Bryston
 677 NEAL DR. PETERBOROUGH, ONTARIO CANADA K9J 7Y4
 PHONE (705) 742-5325 FAX (705) 742-0882

7B SST SERIES MODE SCHEMATIC
 SCHEMATICS FOR INPUT - MAIN - POWER AMP
 FILE: 7B-SST-SCH1C PART No: PAGE 1 OF 2

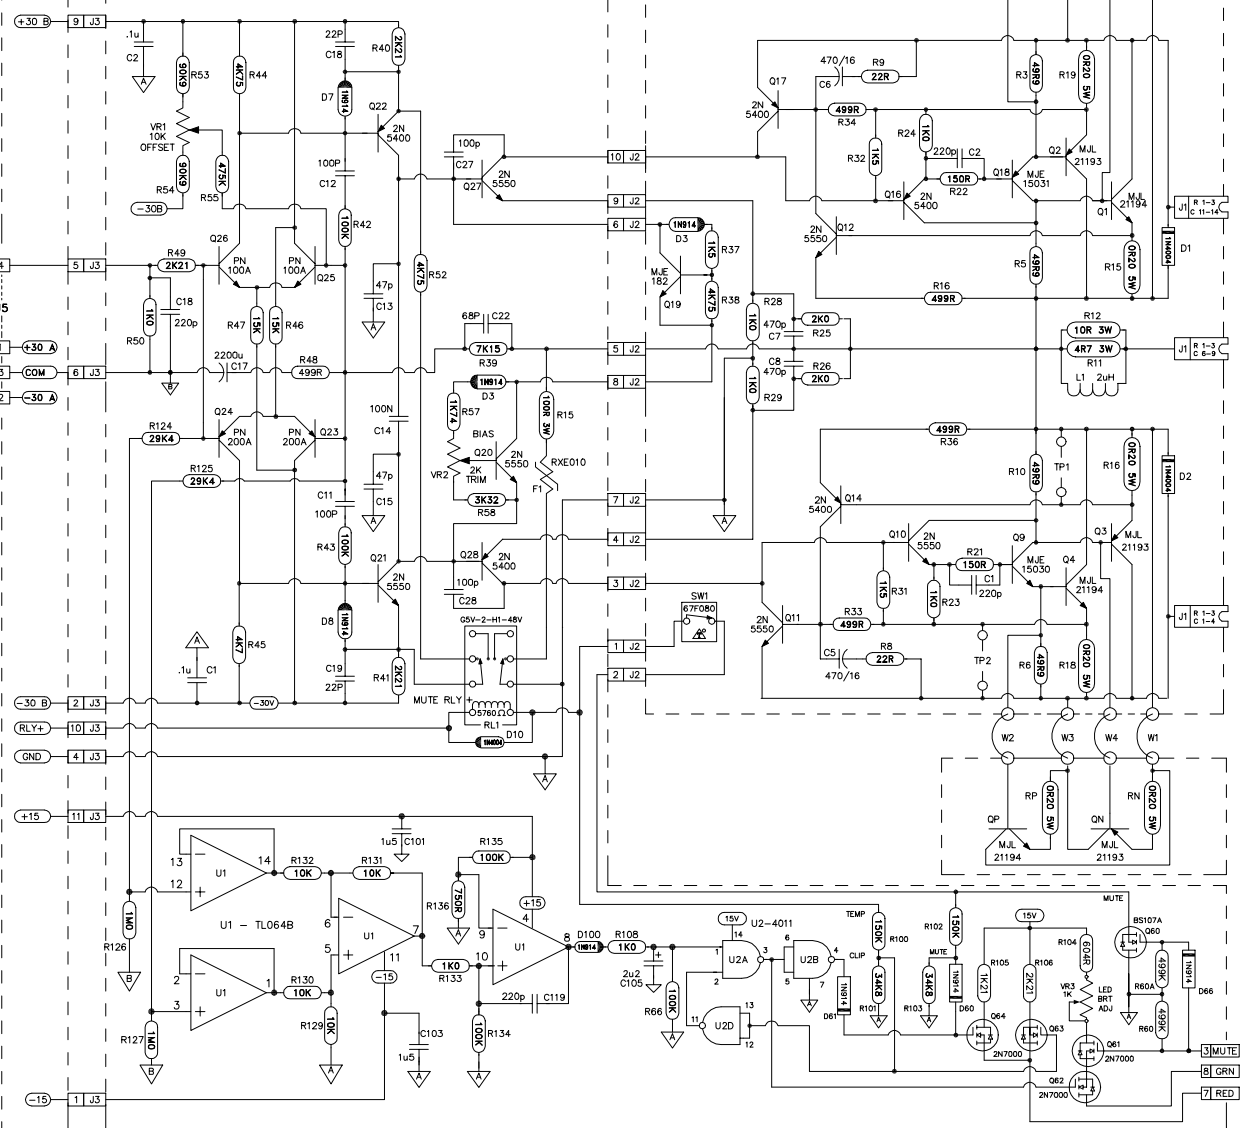
Rev 1c change D3 + D5 ON PSB TO 1N4737.
 Rev 1B change C26, C8 to 10N and R44 to 30K1 on SSB
 REV 1B JULY 9, 02
 ADDED R60A TO MAIN BOARD
